Chau Chak Wing Museum

Response to Heritage Council Submission

State Significant Application SSD 16_7894

Section through Loading Dock Entry

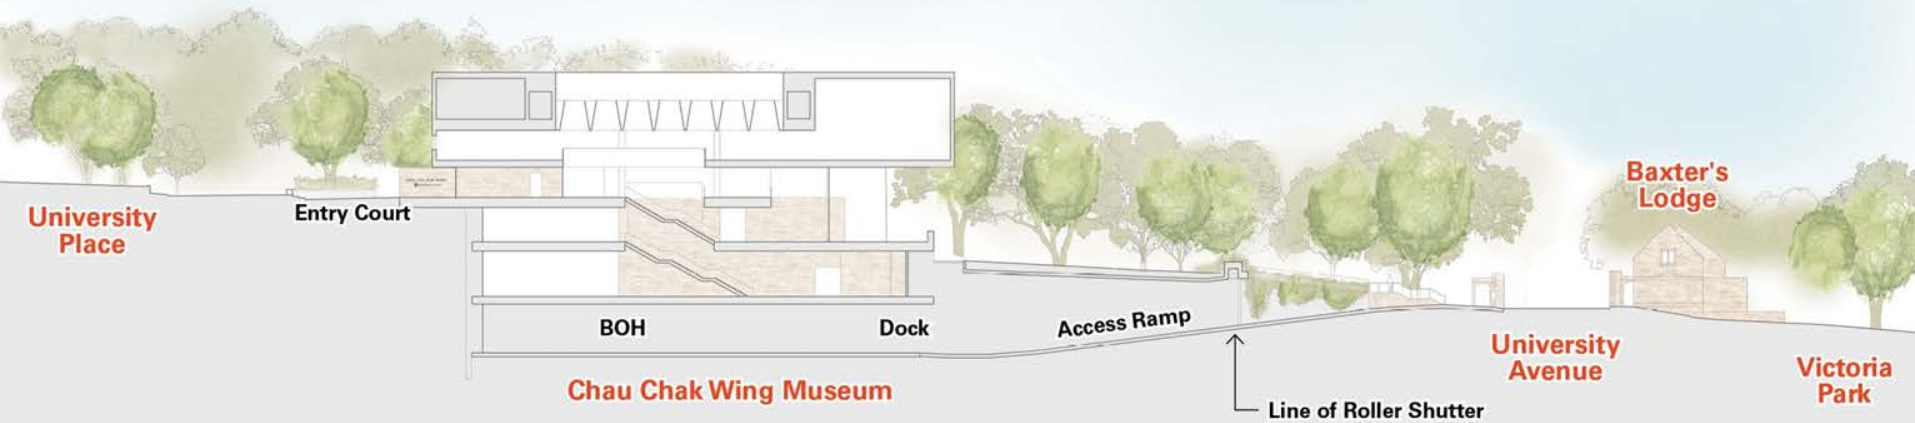
The design does not sit comfortably within the site.	<p>As demonstrated in Image 1, the loading dock entry is located as close as possible to the University entry gates, which allows the majority of the existing site curtilage on University Avenue to be preserved as open landscape.</p> <p>Image 3 offers further evidence that the placement of the loading dock entry close to Parramatta Road is a minor component of the overall view when experienced by the majority of pedestrians arriving at the University via the steps from Victoria Park, when the mounded grass landscape and curved low sandstone wall curtilage is the dominant visual cue.</p> <p>Furthermore, any alternative entry point to the basement would be detrimental to the Quadrangle forecourt if placed to the west, and impossible due to existing tree roots if placed to the south.</p>
The design of the loading dock is not well resolved and the utilitarian design has an unacceptable impact on the heritage values of the site.	<p>USYD has continued to refine the design of the loading dock entry since the SSDA submission, and photomontage Image 2 illustrates a closer view (from Baxter's Lodge) of the existing sandstone retaining wall, and how this integrates with the new high quality materiality of the various terraced walls, the new steps at the end of the existing northern pathway, and the visual bulk and scale is further reduced by the introduction of planting and hedges.</p> <p>The proposed alignment of the roadway and roller shutter position enable the landscape levels around the dock entry to be neatly tied back into the existing topography, so that the existing slope and character of the landscape is the dominant expression, rather than the physical expression of the dock entry itself.</p> <p>The materiality and detailing of the dock entrance and surrounds is consistent with the main building.</p>
